May 4, 2018

Renovation to Tierra Blanca
615 Columbia Drive
Hereford, Texas
CHA# 1728

Bid Documents dated: 4/25/18

Addendum One

1 SECTION AT WALL PANELS
1 1/2" = 1'-0"

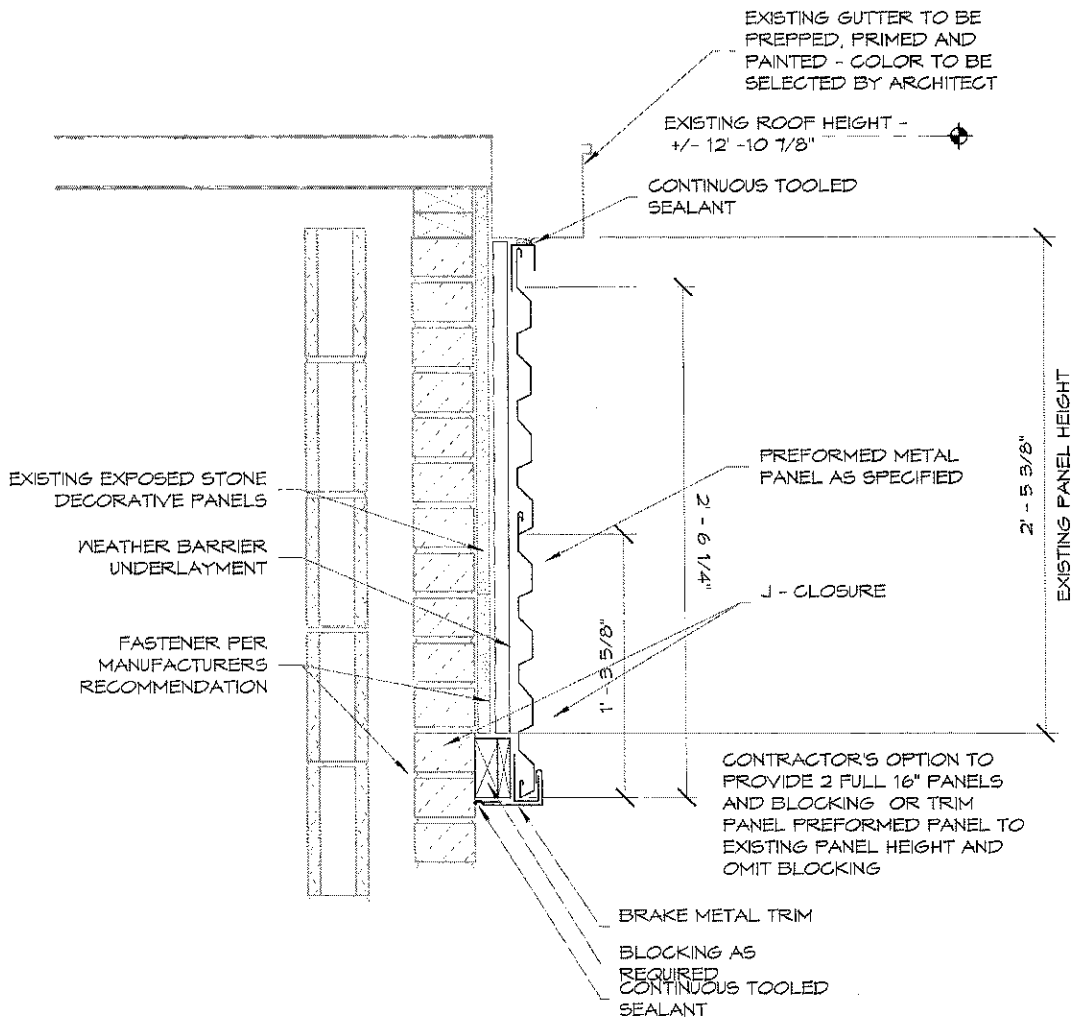
30. Sim detail labeled 12/A14 should read 2/A14.
31. See detail below for section at new panels on existing wall.

2 Detail at Slab Repair at Utility Installation

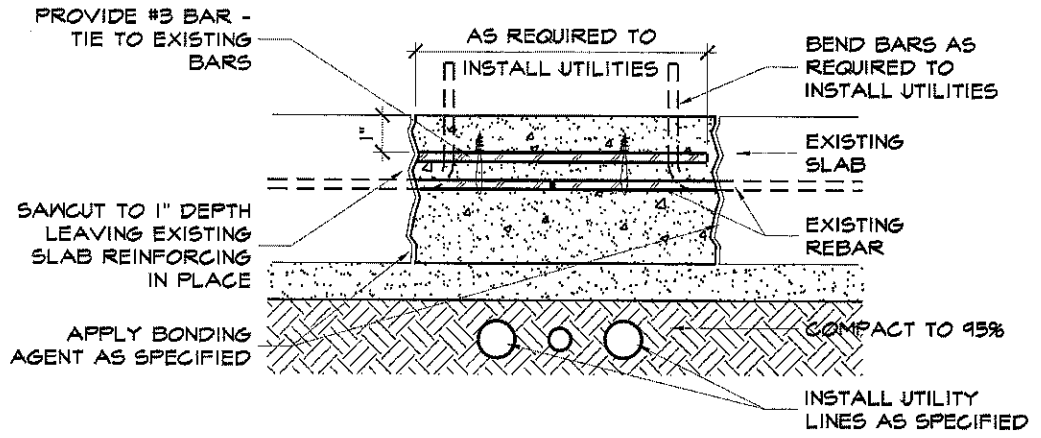
13. All PLAM doors to be factory glazed.
14. Refer to detail below for slab repair at new utility installation. It is contractors option whether to compact or provide flow fill at trench locations. Compaction shall be done in 6" lifts.

15. Contractor is responsible for the correction of any resulting settlement at site utility trench locations.
16. Flooring for Room 149 is to be F1 color to be V1.
